**PLANNING & ZONING CONSIDERATION ITEM**  
**CITY OF FAIR OAKS RANCH, TEXAS**  
**April 14, 2022**

AGENDA TOPIC: Consideration and possible action recommending approval of a Final Plat request from Elkhorn Ridge SA, LLC for Elkhorn Ridge Unit 7 proposing 18 single-family residential lots, generally located north-east of the intersection of Dietz Elkhorn Road and Elkhorn Ridge, City of Fair Oaks Ranch, Texas

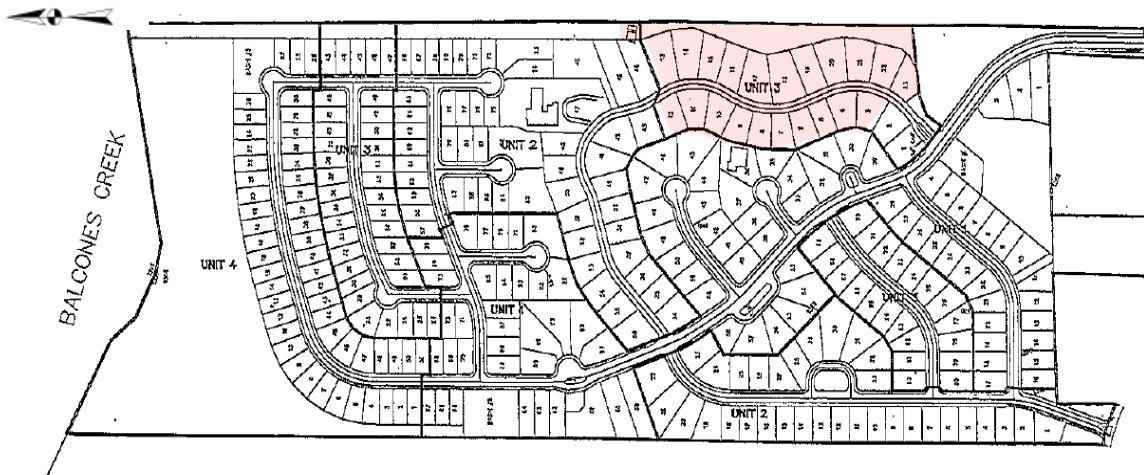
1. Resolve the discrepancy between tax certificate and the plat. Tax certificate shows 6.8 acres whereas the plat and Master Plan indicate 7.082 acres. (The shape matches, however, the area/acreage does not).
2. Correct the discrepancy in the area of the Reserve 914. Plat layout shows 1.37 acres whereas the title block shows 1.36 acres.
3. Correct the plat type in the City signature block. (Still shows Preliminary).
4. Correct the plat note regarding the maintenance and ownership responsibilities of Reserve 914 and Kearney Ridge Parcel 913 to clarify the ownership and responsibility. (Does not specify who maintains the reserve).
